Technical Service Bulletin

SUBJECT: ENGINE CRANK / NO START IN EXTREME COLD – DTC P062D		No:	TSB-22-16-002
		DATE:	March 2022
		MODEL:	2022 Outlander
CIRCULATE TO:	☐ GENERAL MANAGER	☒ PARTS MANAGER	☒ TECHNICIAN
☒ SERVICE ADVISOR	☒ SERVICE MANAGER	☒ WARRANTY PROCESSOR	☐ SALES MANAGER

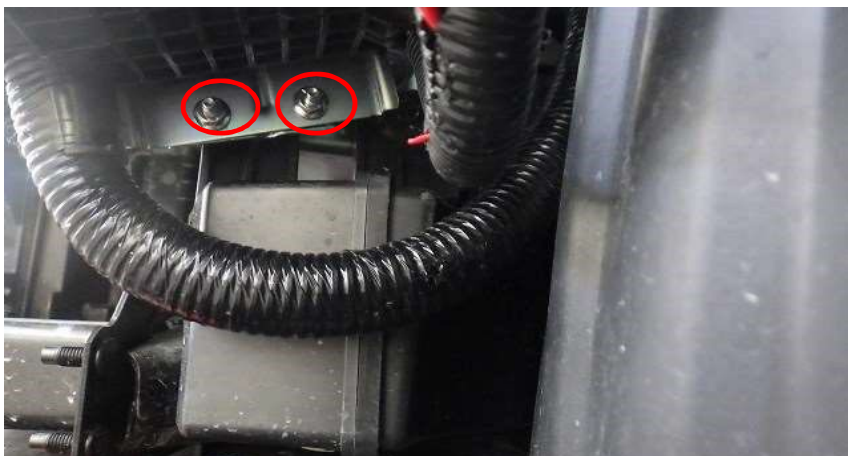
6. Remove the relay box cover.
7. Turn IG-OFF and replace the 4 relays indicated below (INJ, ST CUT, SR MTR x 2).

Photo of front relay box behind front bumper	relay identification
	1 PWM (RAD FAN) relay
	2 ST cut relay
	3 VINJ (INJ) relay
	4 WIPER DEICER relay
	5 H/L washer relay (AWD)
	6 OFF LOAD 2 ION 3 (seat heater) relay
	7 FR WASHER MTR
	8 RR WASHER MTR
	9 SR MTR (A/T)
	10 SR MTR (A/T)
	11 REV LAMP
	12 PTC 1
	13 PTC 2
	14 PTC 3

8. Reinstall all components and tighten the torque of the relay box bracket to: 5 ± 1 N·m.
